Re: Thomas and Nicole Murphy
1695 Dunstable Green
Annapolis, MD 21401

Variance Letter of Explanation

CONFIRMATION OF PRE-FILE

PRE-FILE #: 2024-0102-P
DATE: 11/1/2024
STAFF: Joan A. Jenkins (OPZ)
Kelly Krinetz (OPZ)

Administrative Site Plan

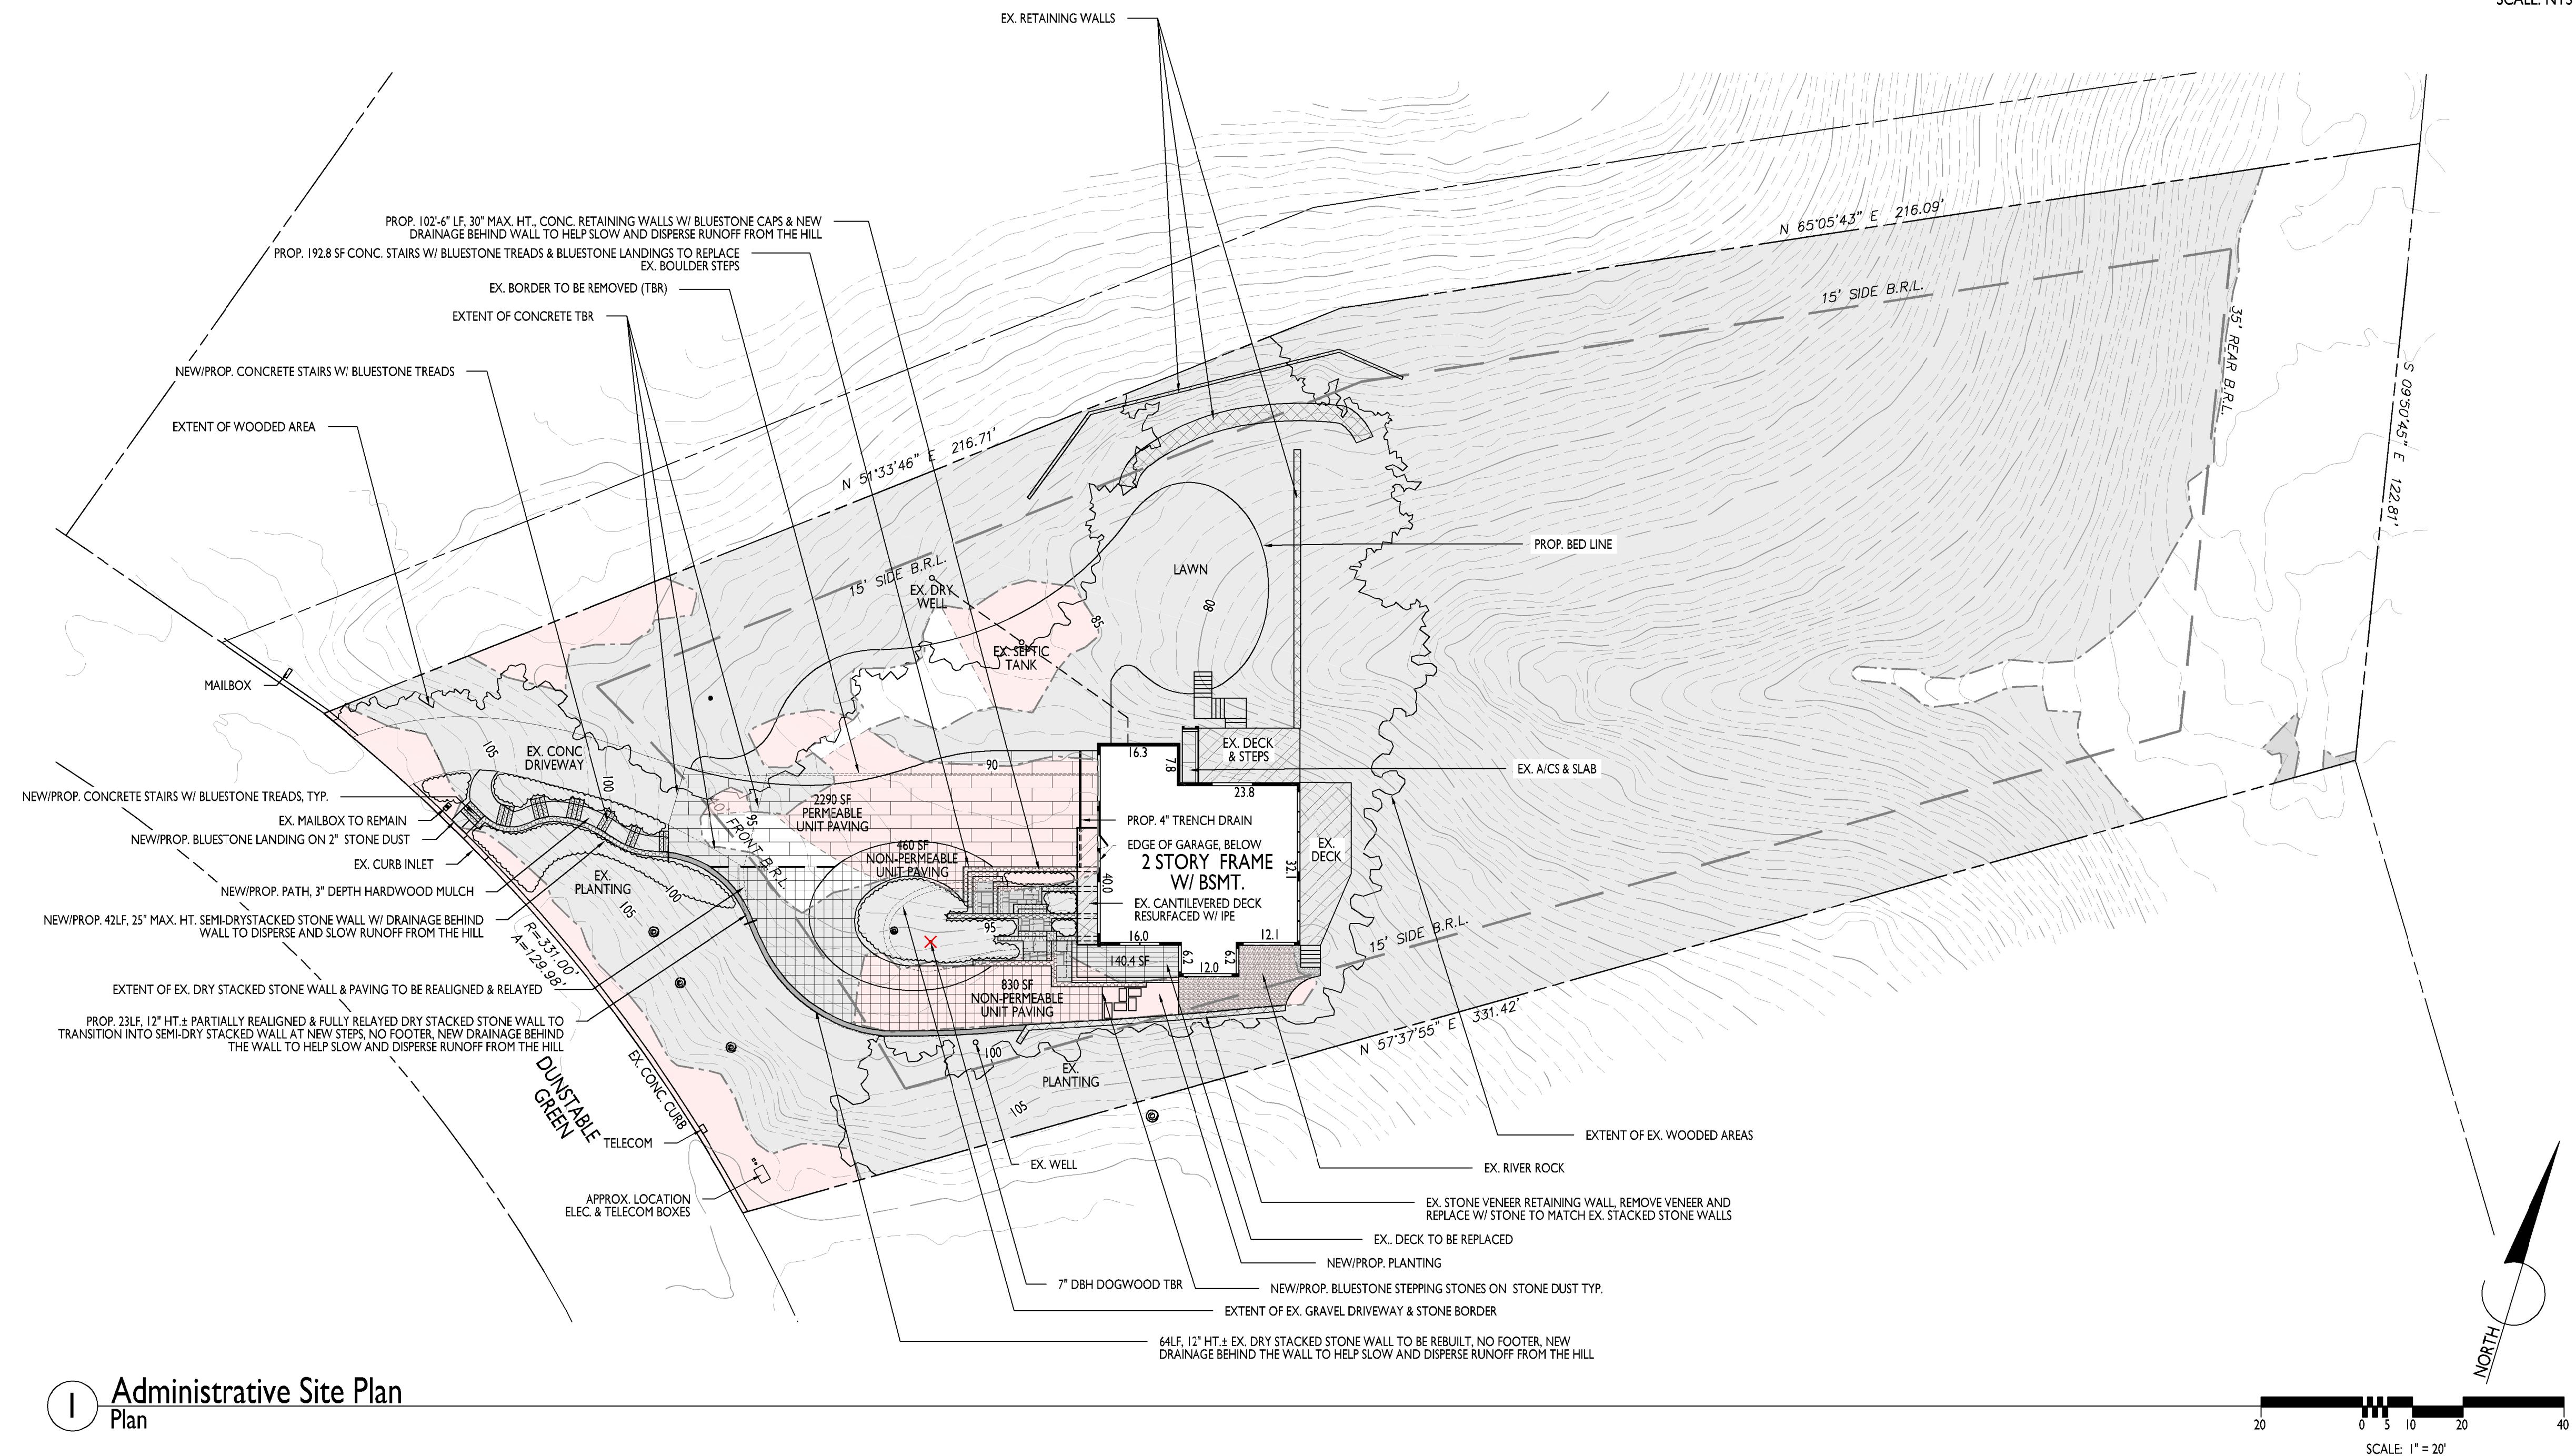
Critical Area Team: For the purpose of clarity, it would be helpful to remove the future phases from the plan unless they are part of this request. For the most part it appears that the proposal is to reconfigure/replace existing improvements. there is no objection to the replacement of existing driveways, decks etc. or the construction of the new steps adjacent to the dwelling. It is unclear if the pathway from the road to the house is replacement or new. Photographs of this area would be helpful and disturbance to the slope should be minimized.

The applicant should make changes to the site plan as recommended by the Critical Area Team if the future phases are not to be included with this variance. Note that future redevelopment may require a variance at the time including replacement in kind of structures. The letter of explanation includes the verbiage 'modification' meaning a change. The OPZ has a process called Modification which is different from the variance process. The letter could be rewritten so as to not cause confusion in that matter. Also, the applicant should address the variance criteria under 18-16-305 regarding critical area variances.
